Addendum #1

Project: Park Manor Public School – Phase 2, 18 Mockingbird Dr, Elmira, ON N3B 1T1
Project No.: 21970
Date: 25 February, 2022

PROJECT:
Park Manor Public School - Phase 2 Interior and Window Enhancements

A101

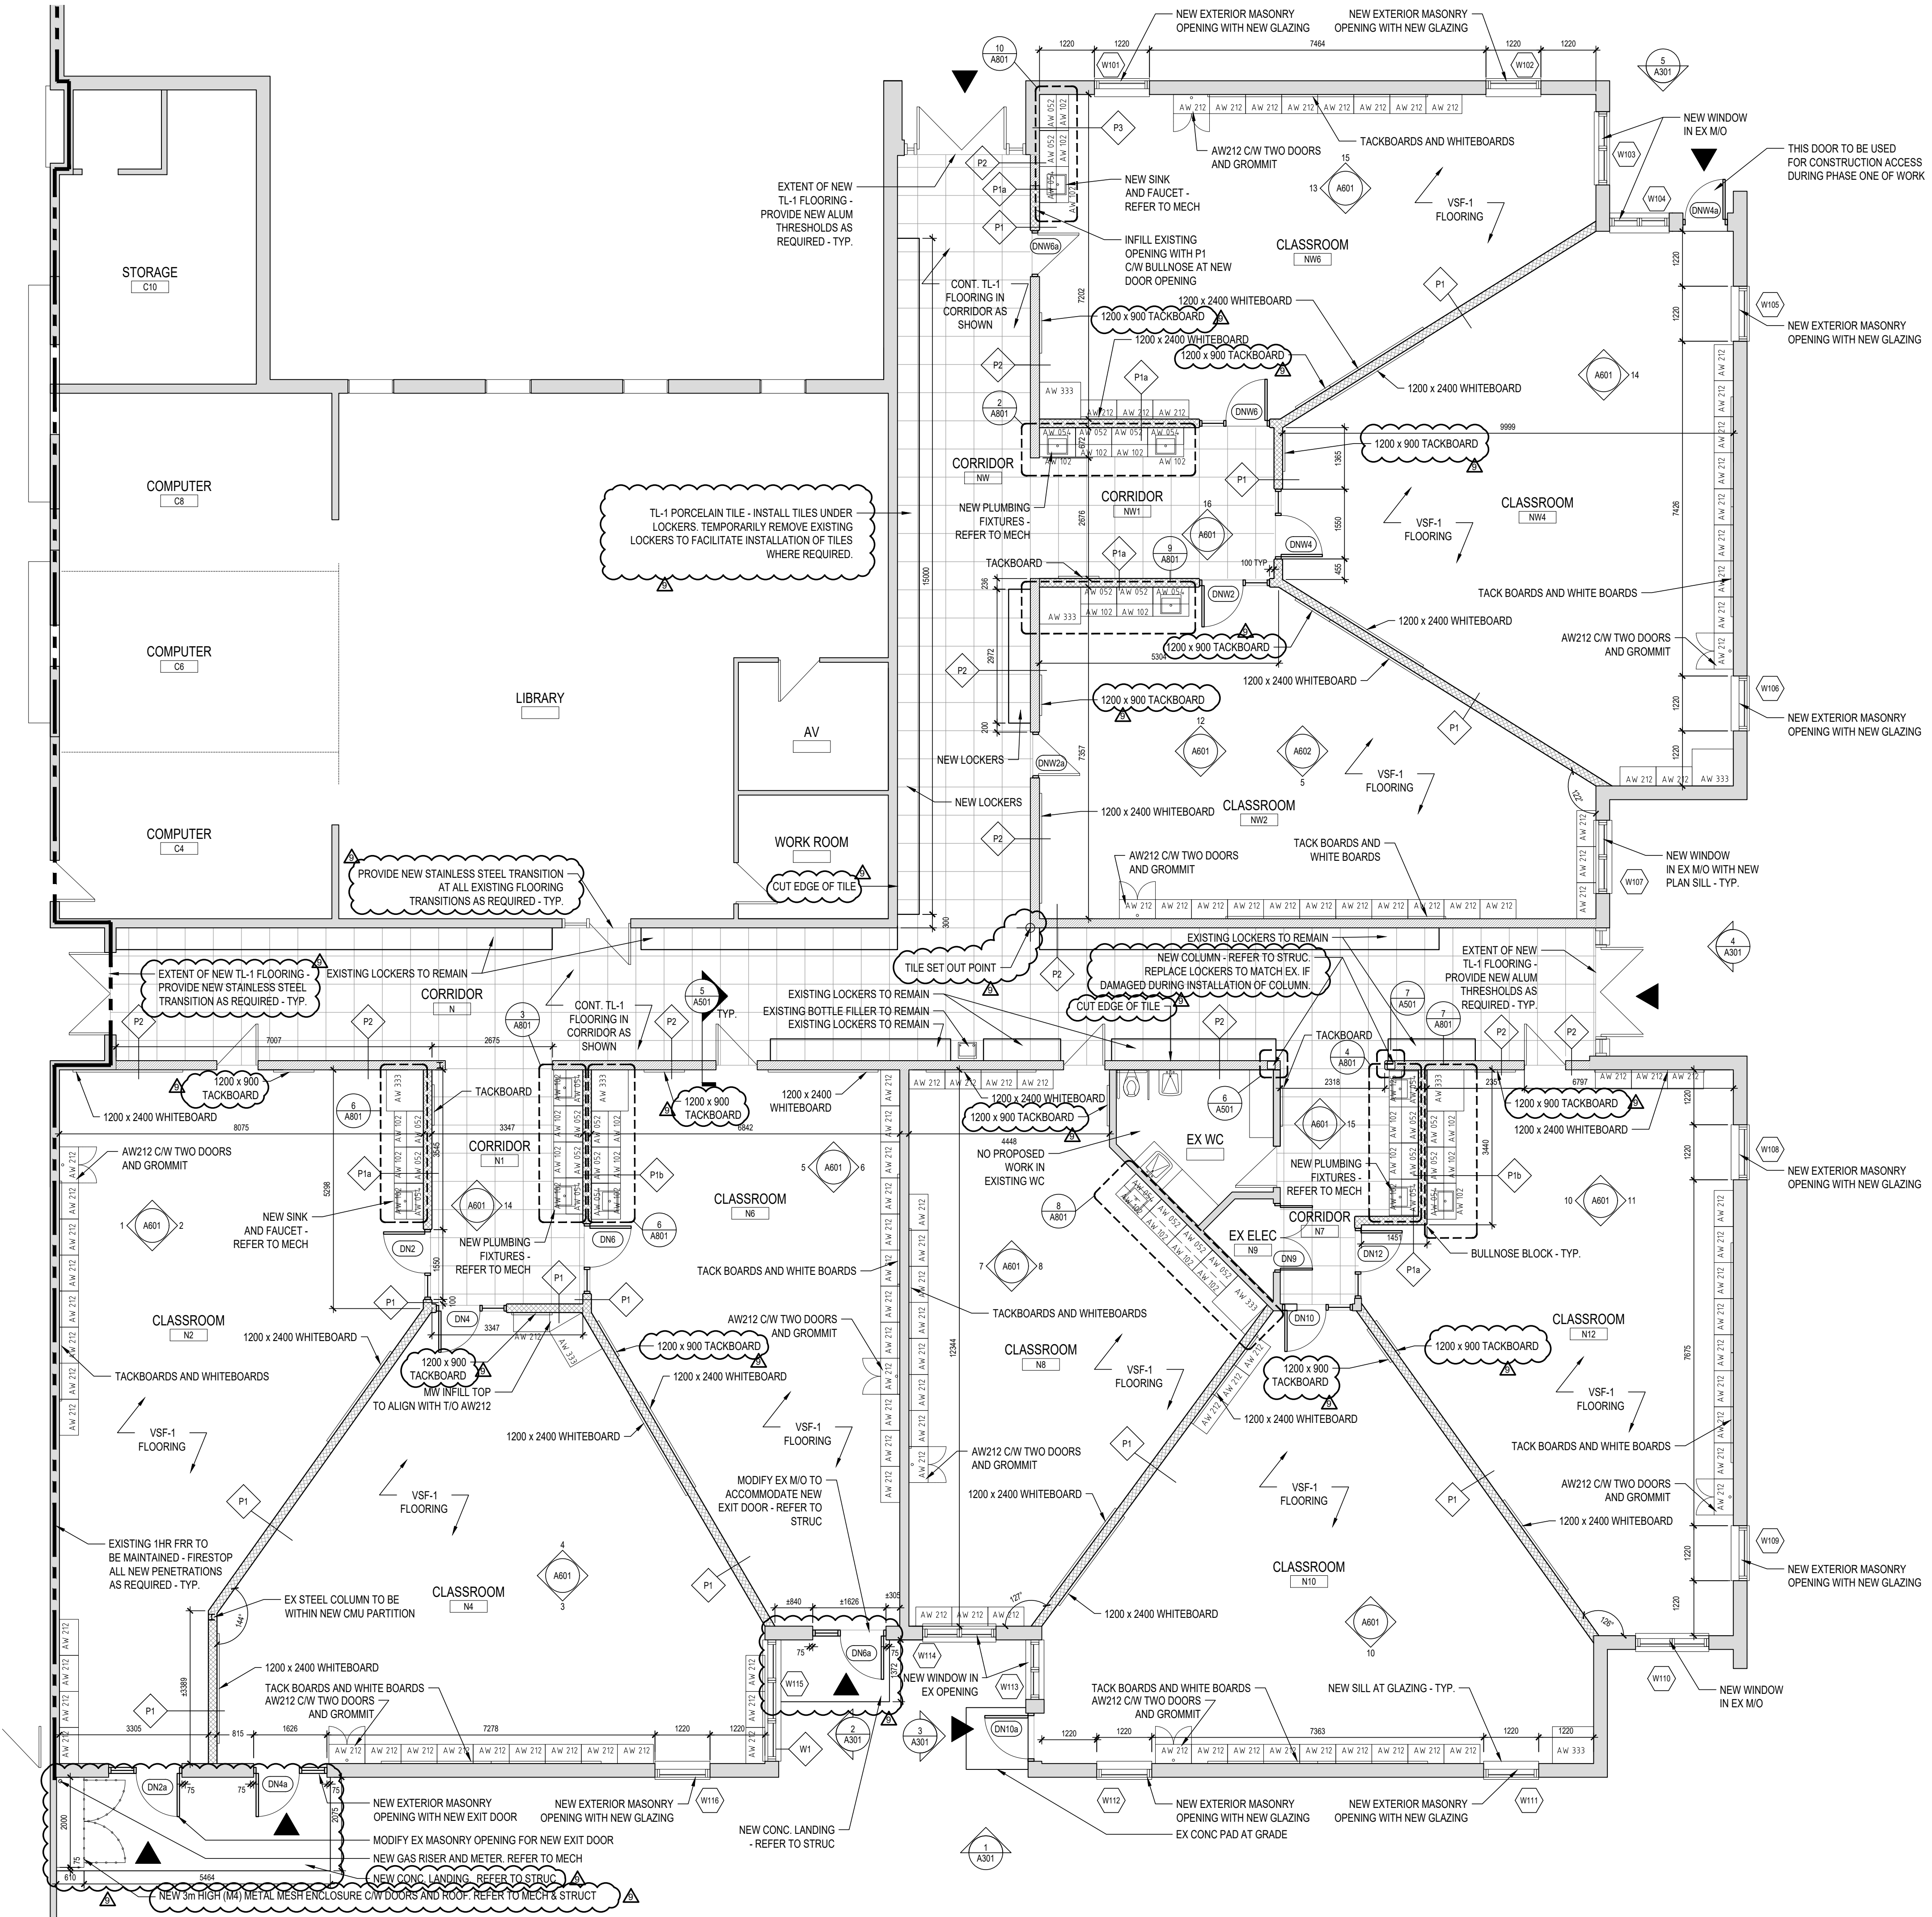
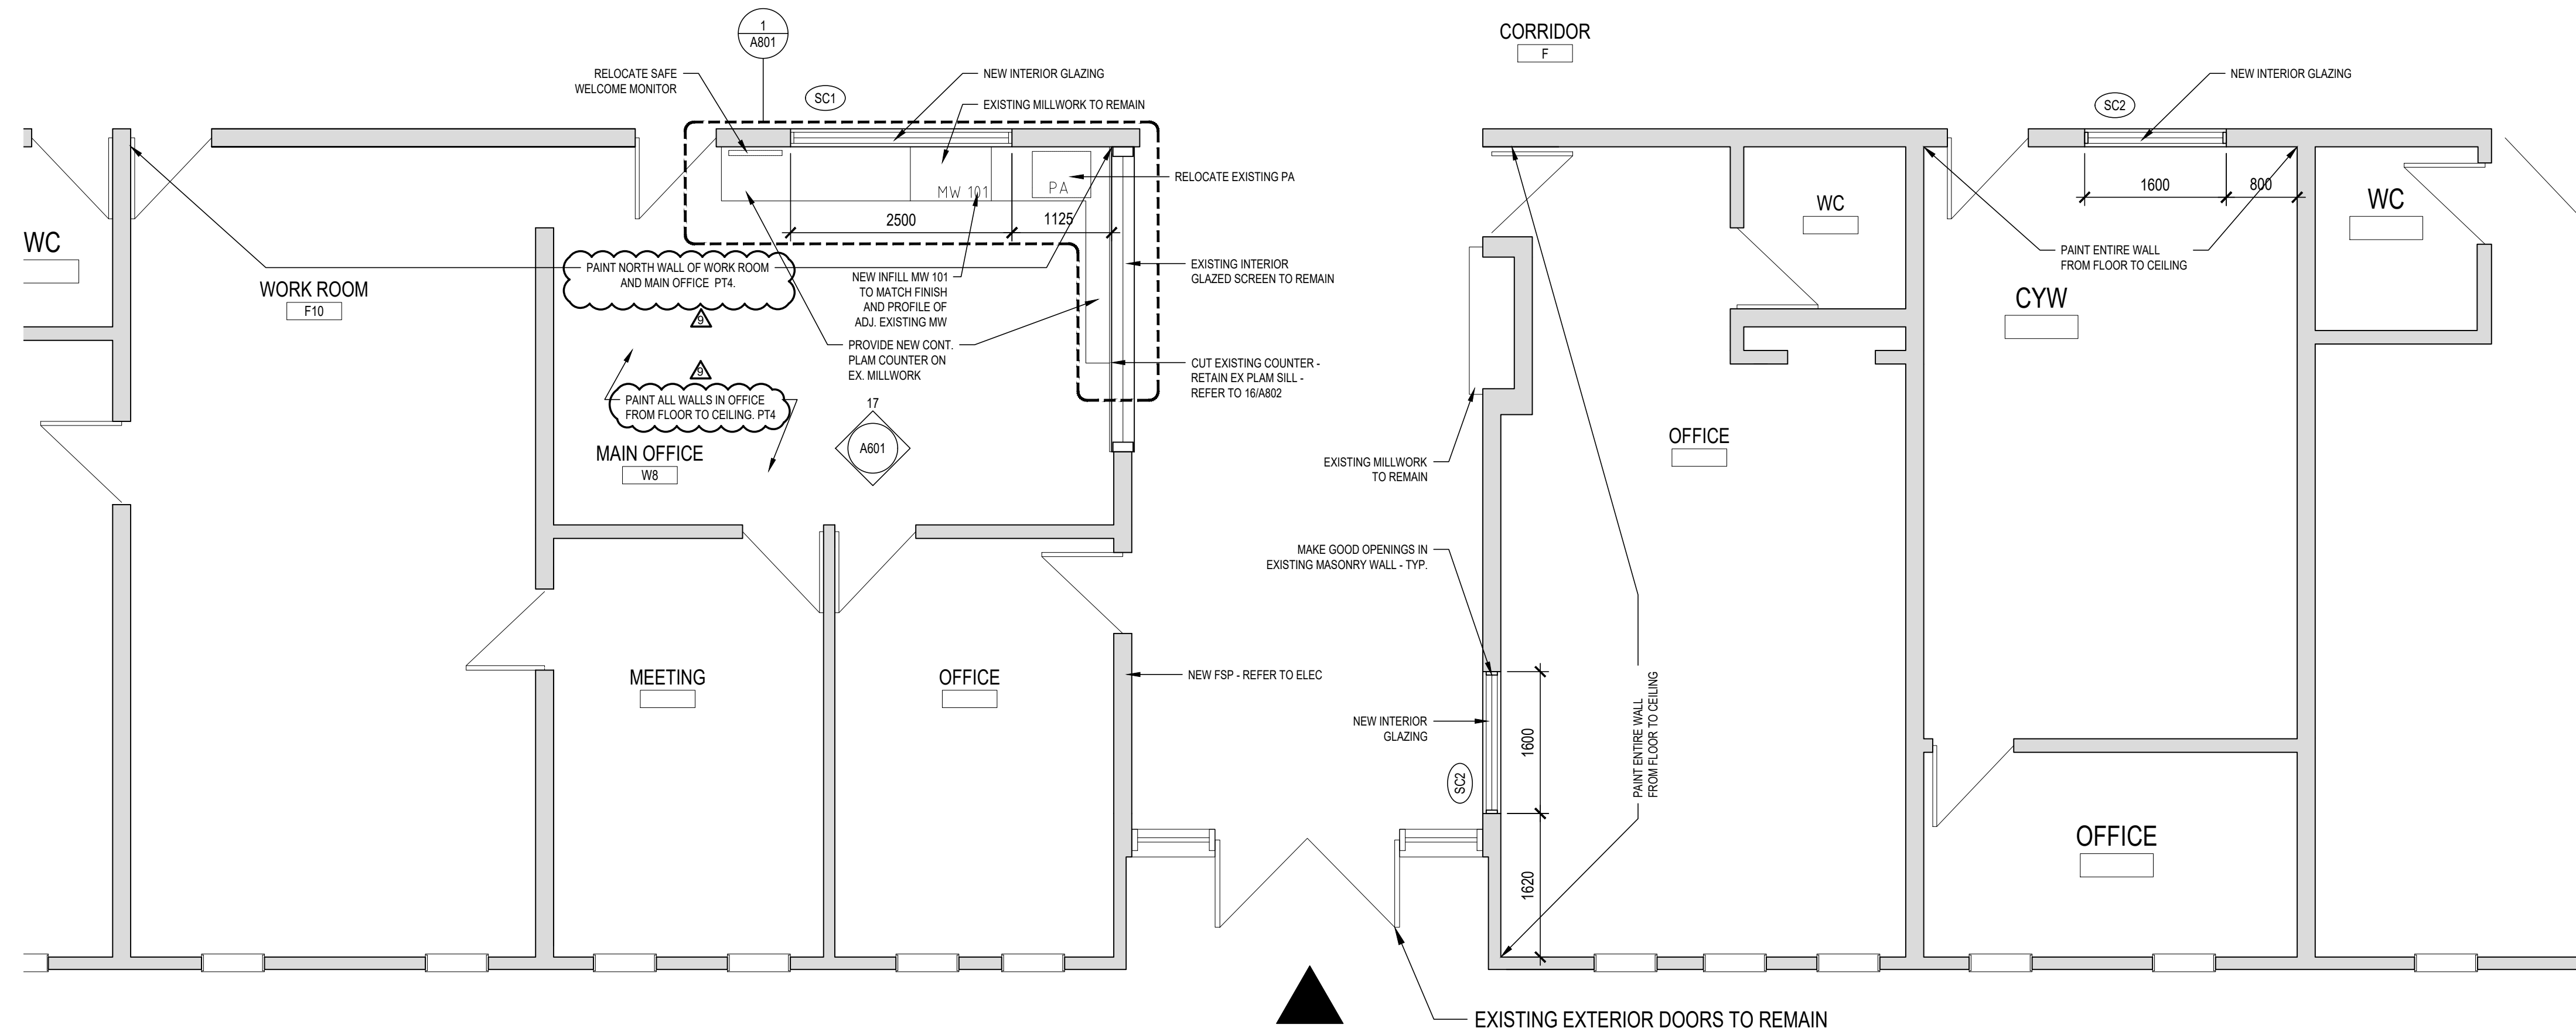
1. **DELETE** all instances of "900x900 Tackboard".

ADD "1200x900 Tackboard" at locations as indicated on the attached Floor Plan.

2. **ADD** note “tile set out point” to the intersection of the corridors.
 3. **ADD** note “cut edge of tile” at locations as indicated on the attached Floor Plan.

4. **ADD** note “TL-1 Porcelain Tile – Install under lockers. Temporarily remove existing lockers to facilitate installation of tiles where required.”

5. **DELETE** note “New column – Refer to struct”
ADD note “New column – Refer to struct. Replace lockers to match ex. if damaged during installation of column.”

6. **DELETE** all instances of “Extent of new TL-1 Flooring – Provide new alum threshold as required – Typ.” at locations are indicated in attached Floor Plan.
ADD “Extent of new TL-1 Flooring – Provide new stainless steel transition as required – Typ.” at locations are indicated in attached Floor Plan.

7. **DELETE** all instances of “Provide new alum thresholds at all existing flooring transitions as required - Typ. ” at locations are indicated in attached Floor Plan.
ADD “Provide new stainless steel thresholds at all existing flooring transitions as required - Typ. ” at locations are indicated in attached Floor Plan

8. **DELETE** all instances of “New concrete step – Refer to Struc” and the dimensions associated with the concrete work.
ADD “New concrete landing – Refer to Struc” and the revised dimensions associated with the concrete landings. The landings are set lower than the interior floor and are to be flush with adjacent grade.

9. **DELETE** all note “New 3m high M4 extruded mesh metal enclosure c/w doors and roof – refer to mech & struct”
ADD “New 2m high (M4) metal mesh enclosure c/w doors and roof. Refer to mech & struct”

A102

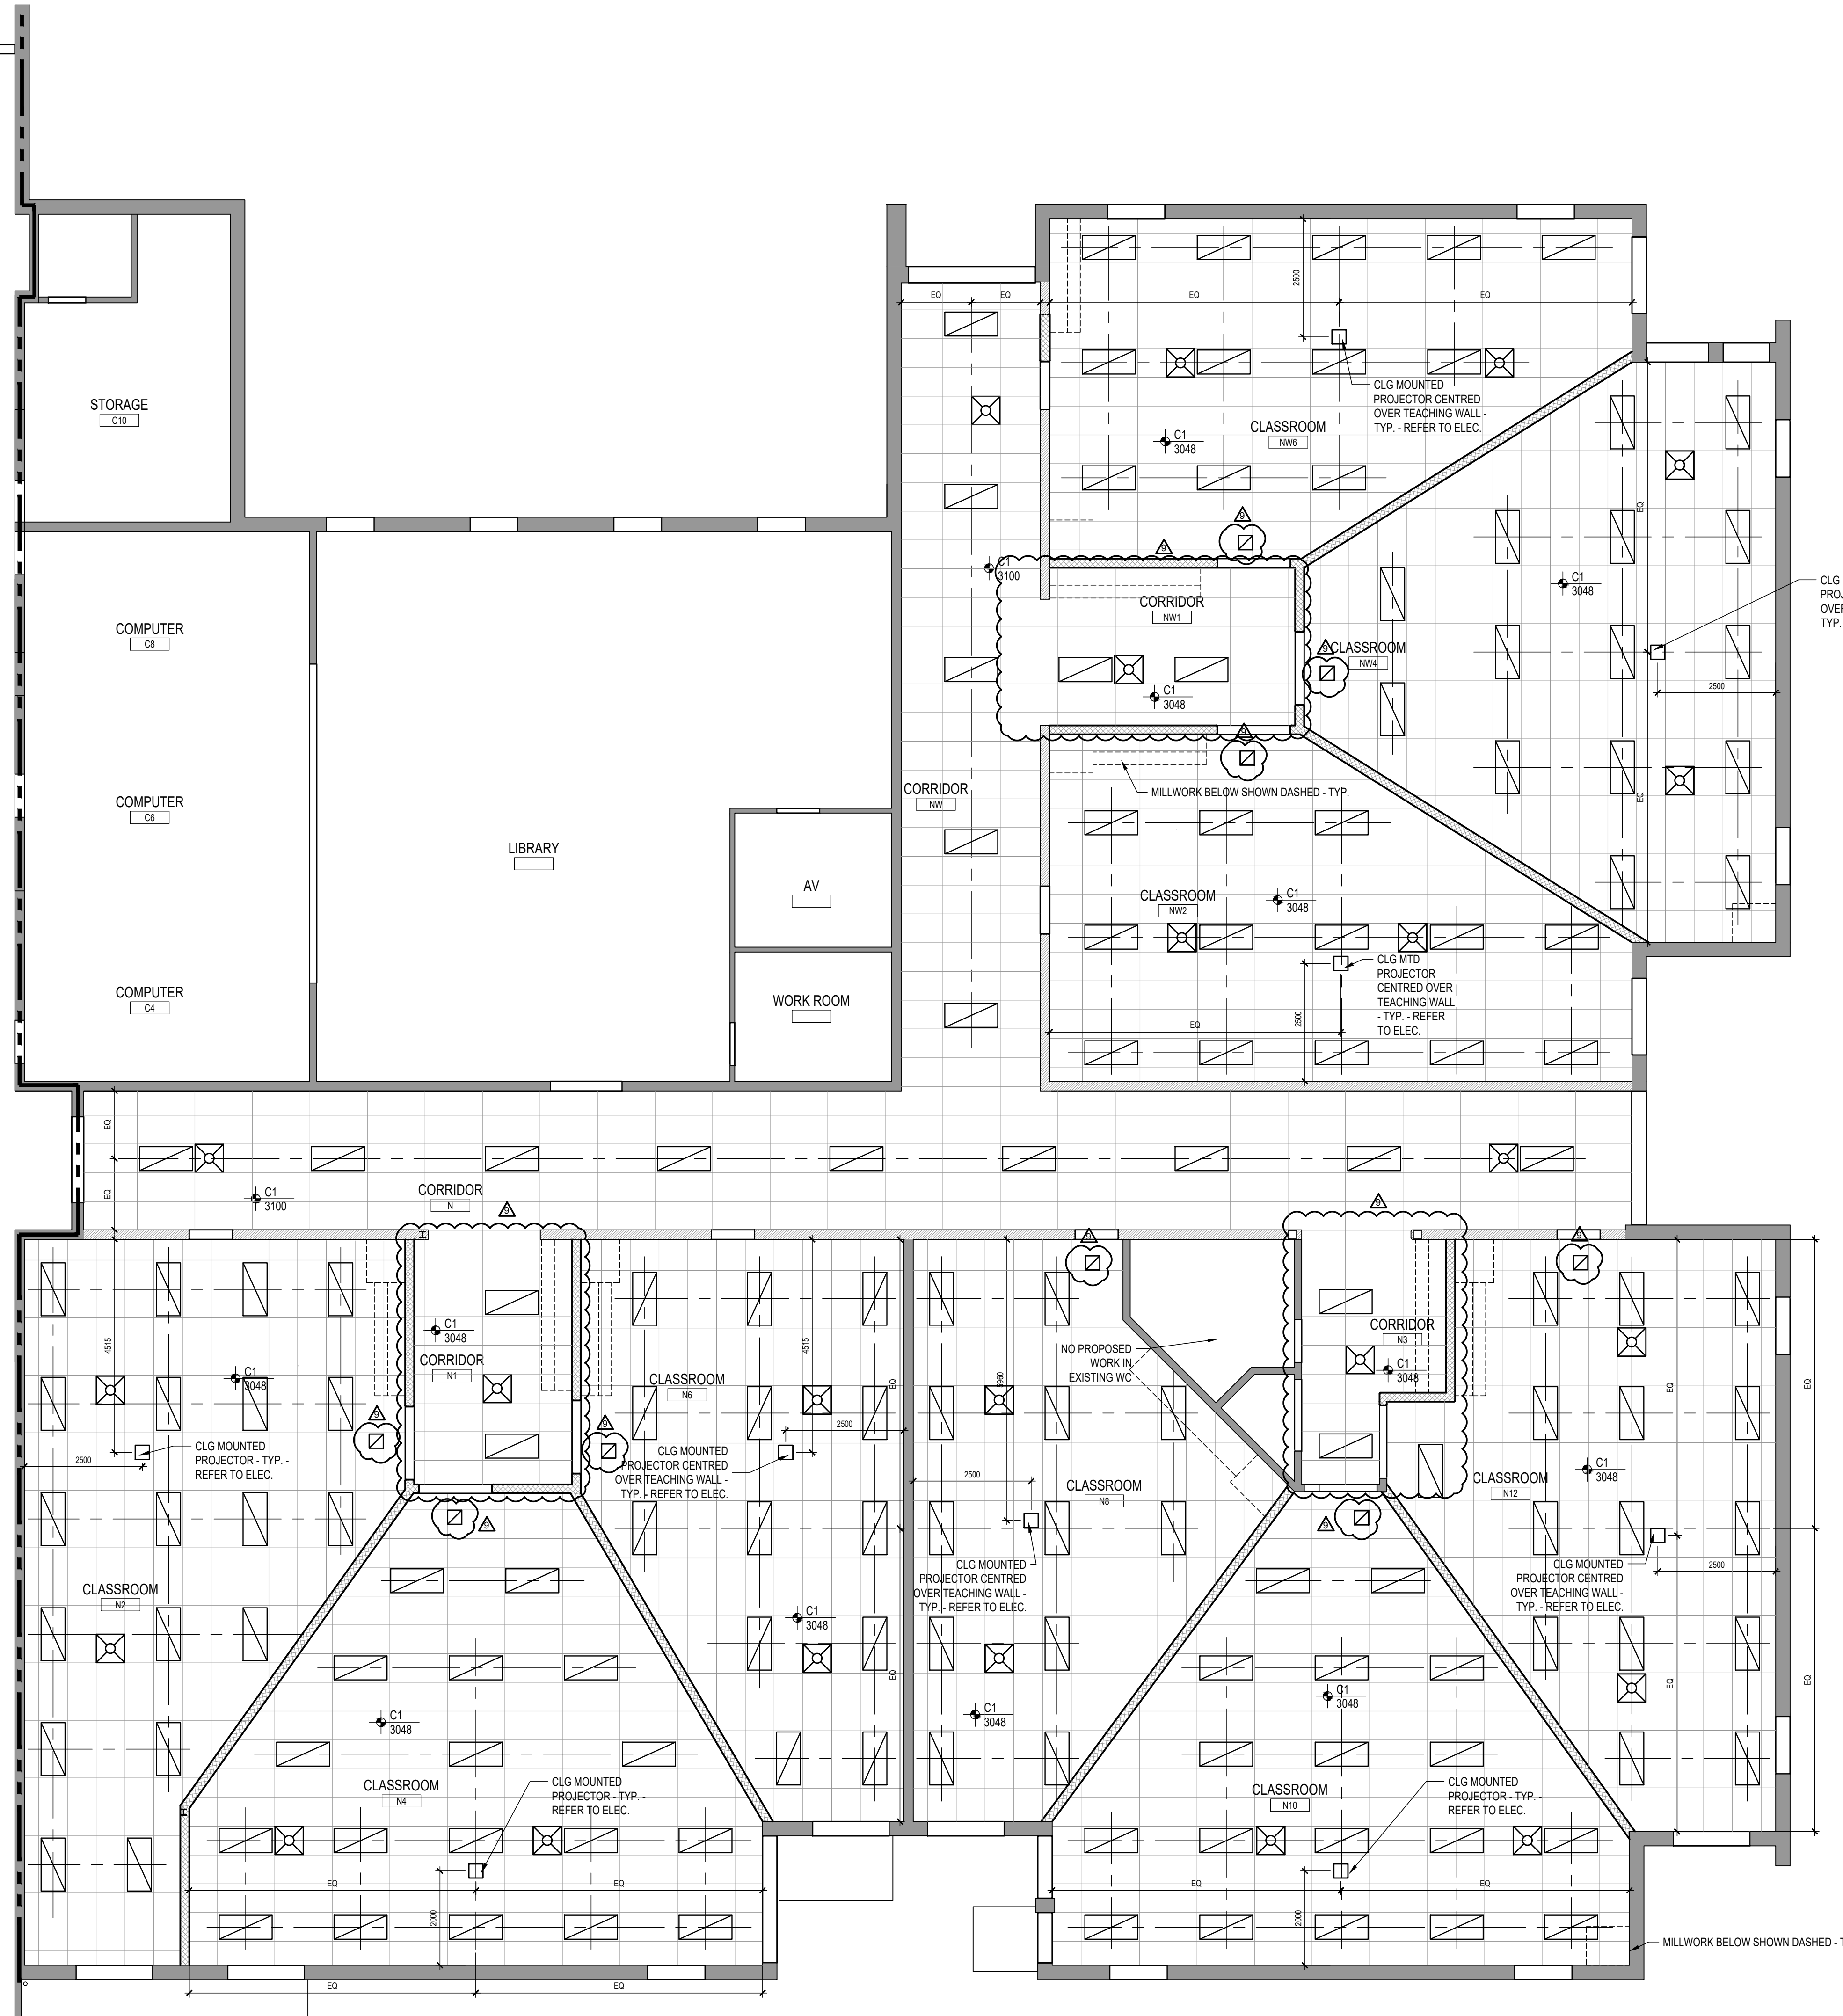
5. A102 GROUND FLOOR PALN – PARTIAL PROPOSED (issued here within)
 1. **ADD** note “Paint north wall of Work Room and Main Office PT4”
 2. **DELETE** note “Paint all walls in Office from floor to ceiling”
ADD note “Paint all walls in Office from floor to ceiling. PT4”
